RE: University of Maryland (License # R-070, Docket # 50-166) Response to Requests for
Additional Information Issued on November 22, 2019

Enclosed please find the University of Maryland's response to the Second Request for
Additional Information Regarding the License Amendment Request for the Use of 16 Additional
Fuel Elements.

**ANALYSIS OF THE NEUTRONIC BEHAVIOR OF THE MARYLAND UNIVERSITY TRAINING
REACTOR, REVISION 4**

Figure 1: Reactor Power vs Fuel Temperature as modeled by General Atomics using RELAP in 2011.

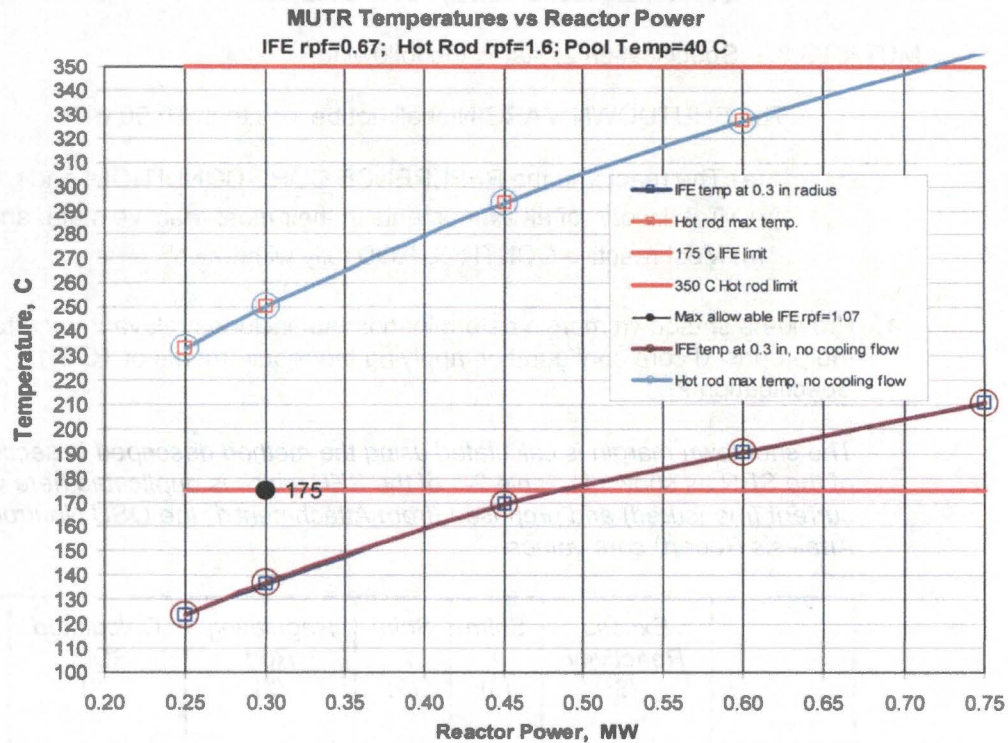
1. Provide a ramp reactivity analyses, taking into consideration the proposed excess reactivity limit of $\$3.50$, starting at both high and low power conditions for the proposed core configuration. Provide the values of maximum fuel centerline temperature and maximum power achieved for all scenarios evaluated.

2. Explain the methodology, inputs, and assumptions used in the control rod withdrawal analysis.

A ramp insertion of reactivity analysis was performed by considering the maximum power that ramp insertion of reactivity would result in, and using the RELAP analysis performed by General Atomics in 2011 (ML110350175) to determine the maximum fuel temperature. This analysis is a bounding case for the proposed core as described in the response to RAI #1.3. 3 scenarios were considered, (1) a ramp as quickly as possible from low power, (2) a ramp from full power just below the scram setpoint, and (3) a ramp with no functioning Reactor Safety System.

In the first case, the reactor power is initially taken to be 1W and the fuel temperature to be 20°C. The control rods withdraw such that a 5s period, just below the period scram setpoint, is maintained during the ramp. The reactor will be scrammed by the 2 independent power scram channels when it reaches 300kW. Assuming a 1s delay between reaching the scram setpoint and the control rod release terminating the power rise to account for channel response time, the reactor power will increase to 366 kW. According to the 2011 Thermal Hydraulic Analysis (Figure 3-3) by GA the peak fuel temperature at 366kW is approximately 270°C, below the maximum operational, 350°C, fuel temperature allowed by the TS, and far below the 1000°C Safety Limit.

In the second case, the MUTR is operating just below the 300kW power scram setpoint when uncontrolled rod withdrawal begins inserting $\$0.30$ per second. It would immediately reach the scram setpoint monitored by 2 independent scram channels. Assuming a delay of 1s from reaching the scram setpoint to the rods being released, $\$0.30$ of reactivity would be inserted. This would cause the reactor to prompt jump to 429kW before control rod insertion could terminate the power rise. According to the GA analysis, 429 kW corresponds to a peak fuel temperature of 285°C, still well below the maximum allowed operating temperature and Safety Limit.

In the third case, it is assumed that the Reactor Safety System is inoperable when the ramp begins. In this case, the MUTR would increase in power until all excess reactivity was inserted. The MUTR's power coefficient of reactivity is $\$0.0053/\text{kW}$ as described in the SAR. Assuming $\$3.50$ of excess reactivity, the peak power reached would be 661 kW. Using the GA analysis, this corresponds to a peak temperature of about 340°C, still below the maximum allowed operating fuel temperature and with a 660°C margin to the Safety Limit. This is not a plausible scenario as there are 2 independent scram channels that will terminate the reactivity insertion at 300kW as well as a period scram channel that will terminate reactivity insertion if the period exceeds 5s. Any 1 of these 3 channels, if operational, would prevent an uncontrolled rod withdraw from reaching this power level, and all undergo a channel test prior to each operation.

Figure 14 – Historic MUTR Control Rod Worth Data

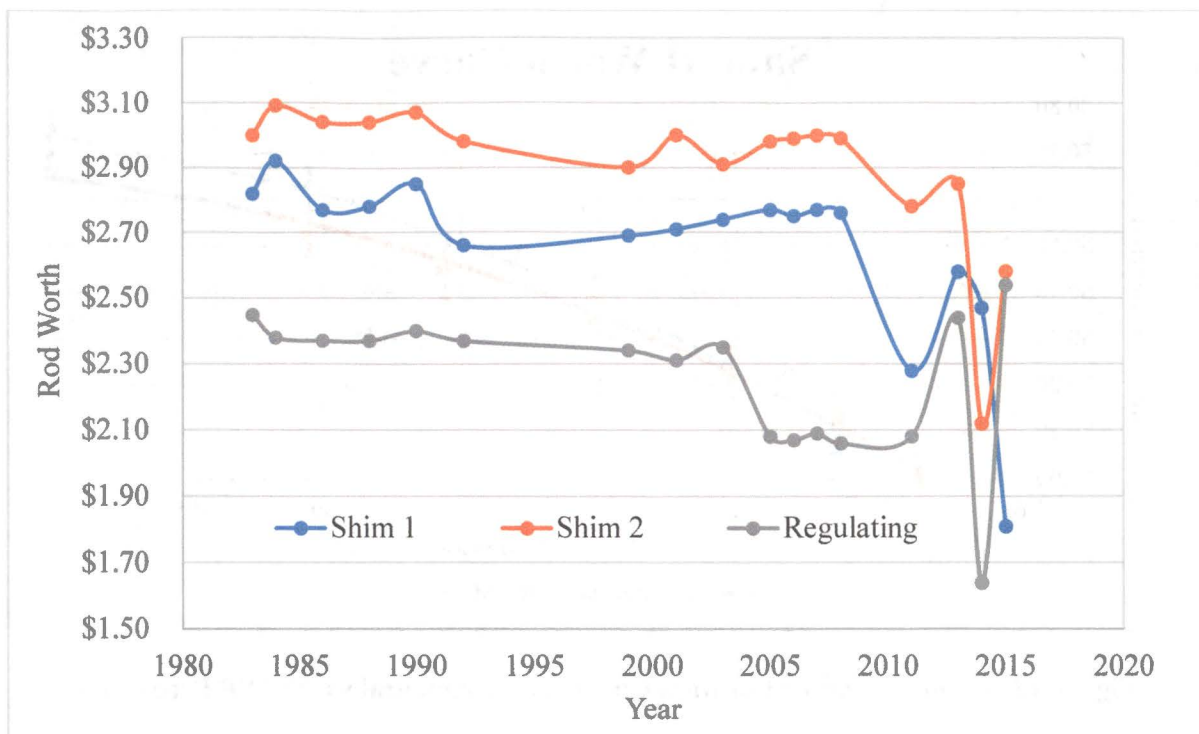
3. Provide a current graph and quantitative data of measured control rod reactivity worth from 2010 to 2019 (Figure 14 – Historic MUTR Control Rod Data).

See Attachment 3, Control Rod Worth Data.
